FDOT DESIGN STANDARDS FY 2012/2013

ARROW BOARD MODE MOVE/MERGE Where adequate shoulder width is not availa the advance warning vehicle may drive in th		
R1301 WORK WITHIN TRA	WEL LA	NE
ATIONS WORK ON N TRAVEL WAY	index no. 619	sheet NO. 2

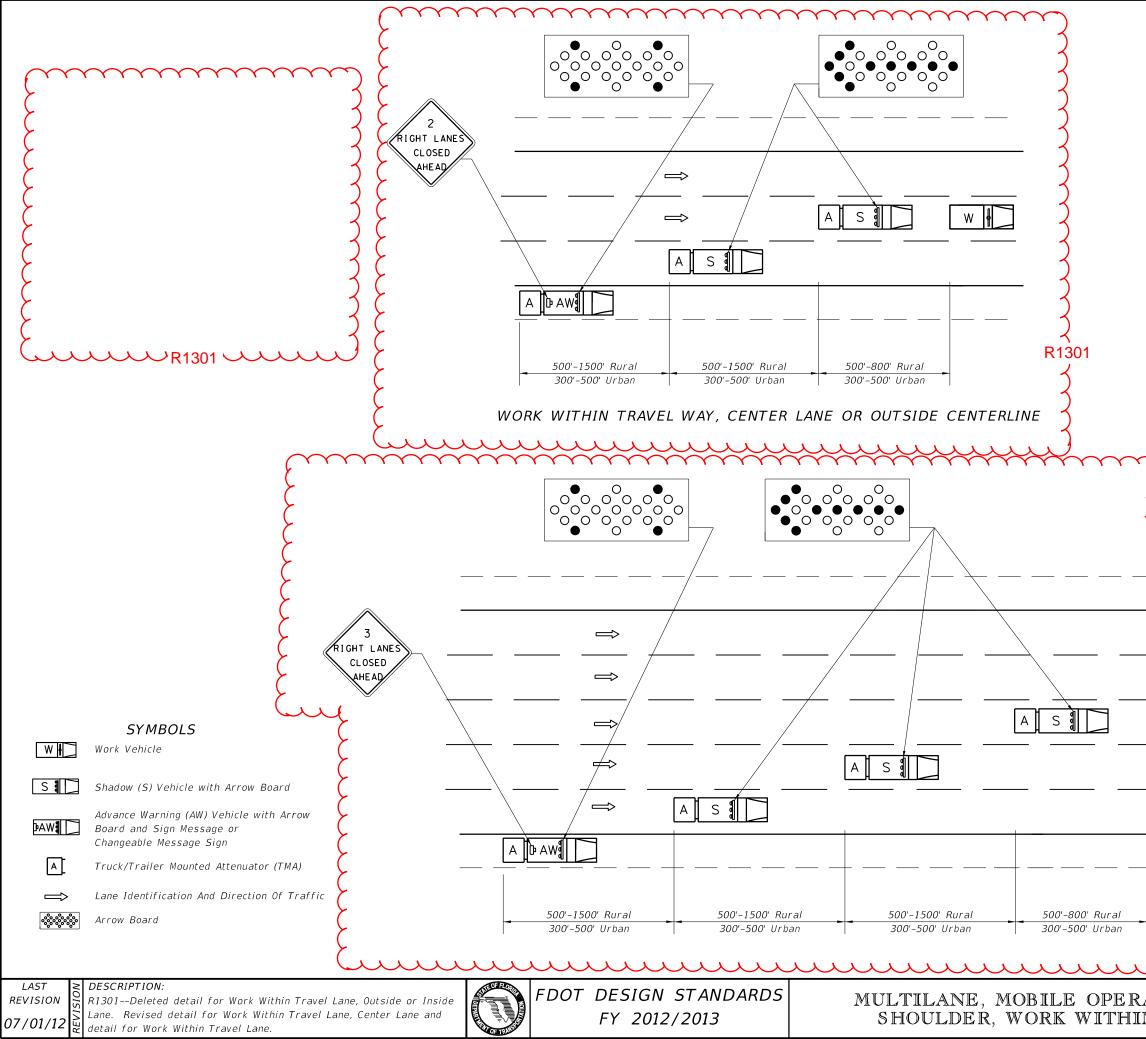
REVISION R1301--Added new Note 2, Notes 3, 4, 5 and 8 revised. Revised detail for Work on Shoulder and detail for Work Within Travel Lane. 07/01/12
